SUBJECT: Historic Area Work Permit # 1058866 - 7305 Baltimore Avenue, Takoma Park

The Montgomery County Historic Preservation Commission (HPC) has reviewed the attached application for a Historic Area Work Permit (HAWP). This application was **approved with two conditions** at the March 6, 2024, HPC meeting:

McGary - Cohen Residence
 Proposed Screen Porch Project
 7305 Baltimore Ave, Takoma Park, MD

1 Proposed Exterior Rear Elevation
Scale: 1/4" = 1'-0"

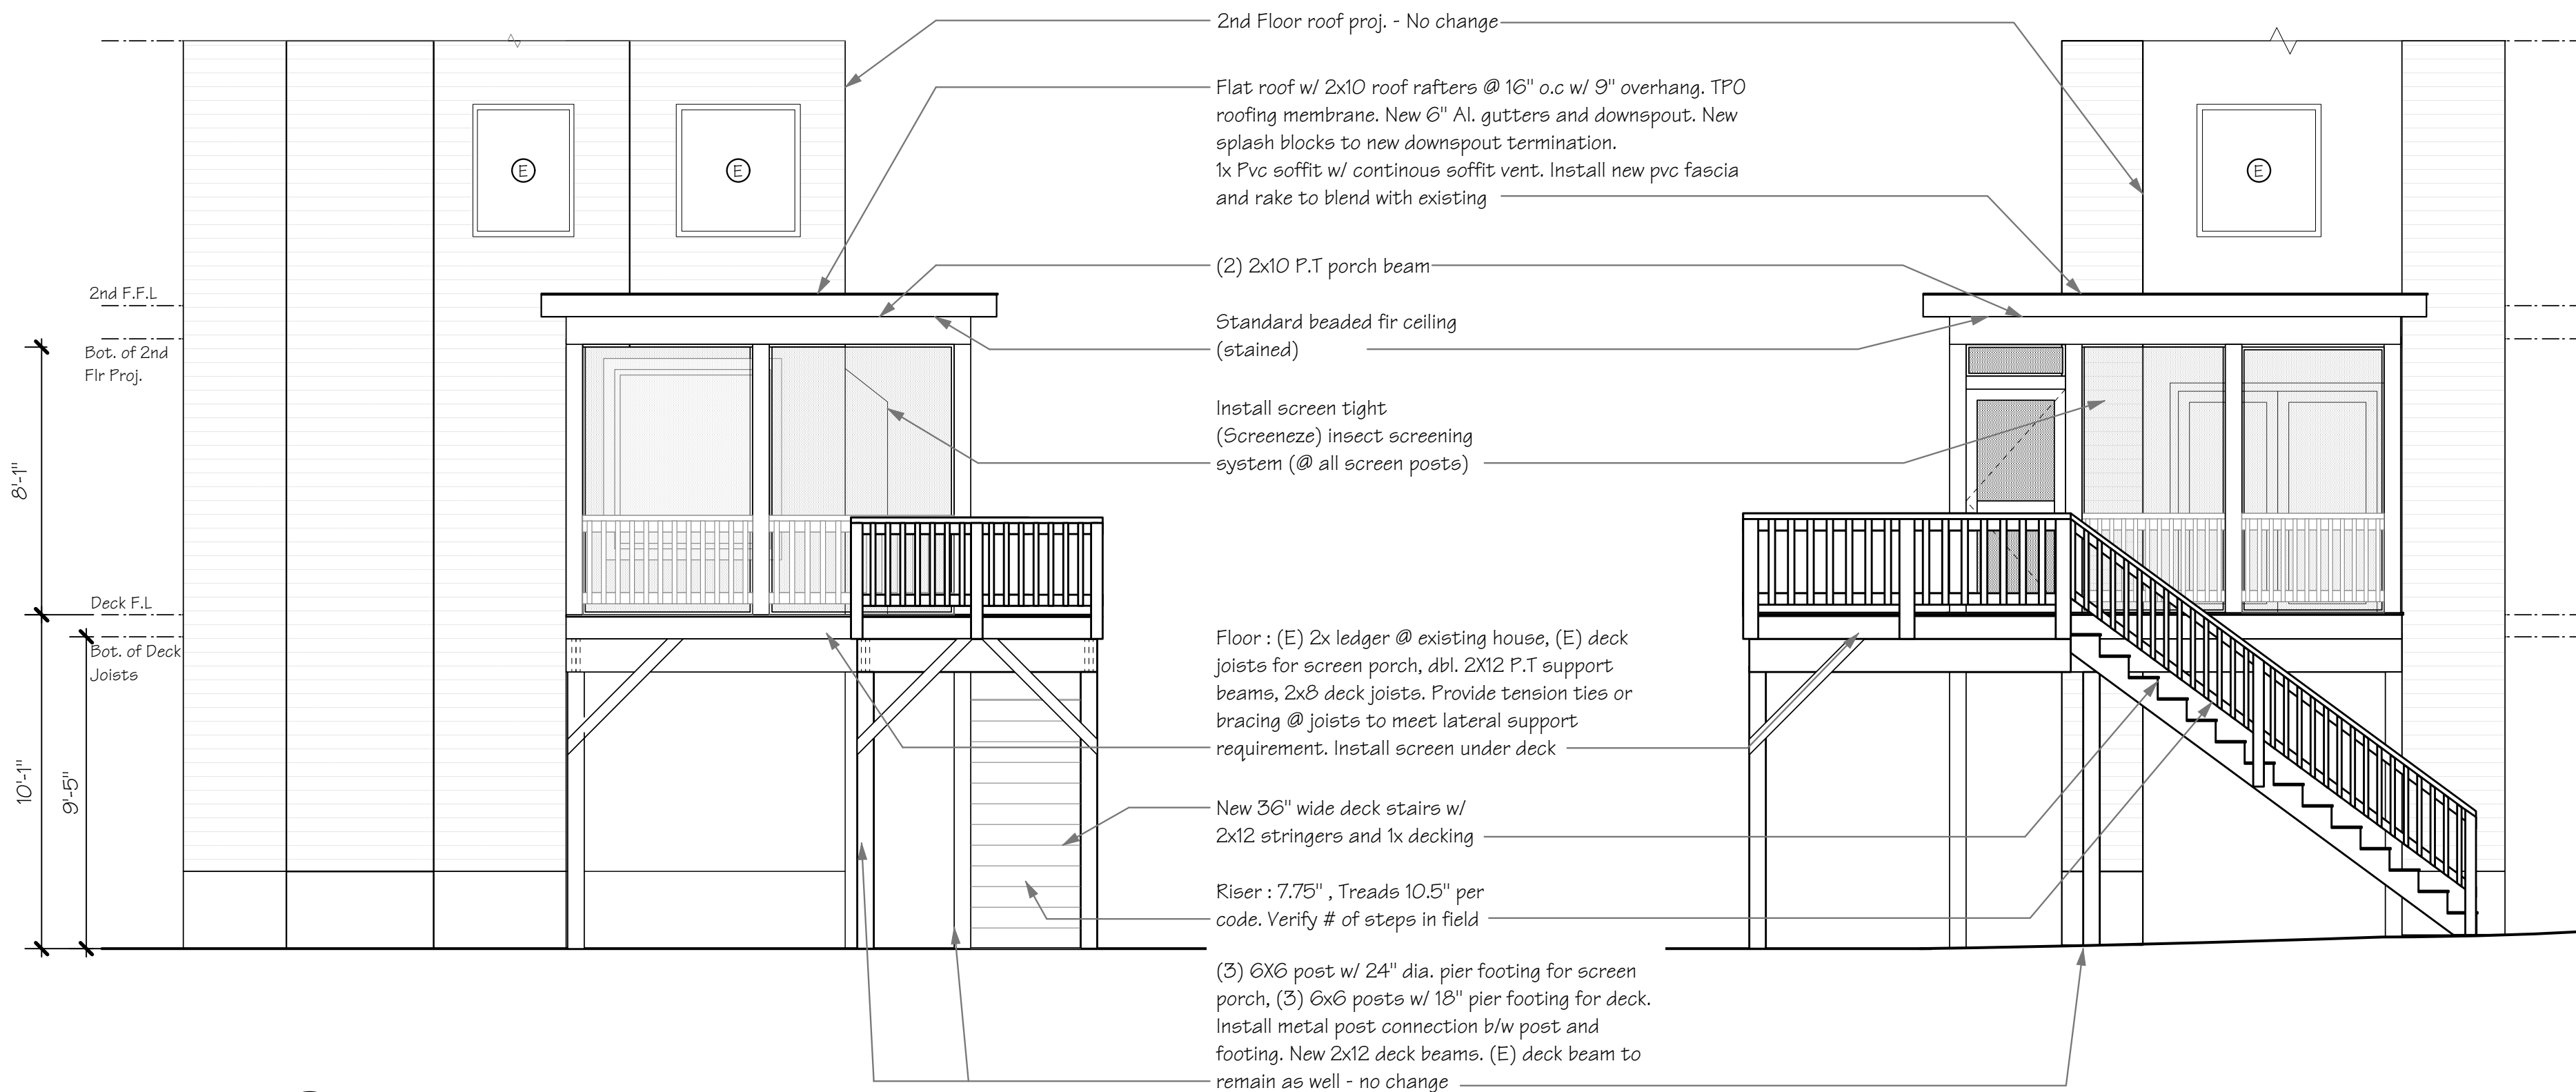
Can you please explain why the porch will have a flat roof? The commission members may question why the roof isn't sloped, so I'd like to include your justification in the staff report.

The porch will have a flat roof (slope ¼" per sq. ft) because of the existing second floor projection not being symmetrical to porch footprint. We are keeping the existing footprint of the deck and will convert it into screen porch (with new structure). We wanted to keep the porch design and roof symmetrical to the existing projection and it was not balancing the elevation

well with sloped roof because of angled wall/proj. on 2nd floor.

Also, There are few different roof pitches on the main roof already and adding another roof pitch would have created off balance to rear elevation. Flat roof balances the overall rear elevation.

The 2nd floor projection has a window so roof pitch for sloped roof would have been tricky as well.

We will be installing new gutters throughout the new porch and 2 new downspouts to splash block and flat roof will have a TPO membrane.
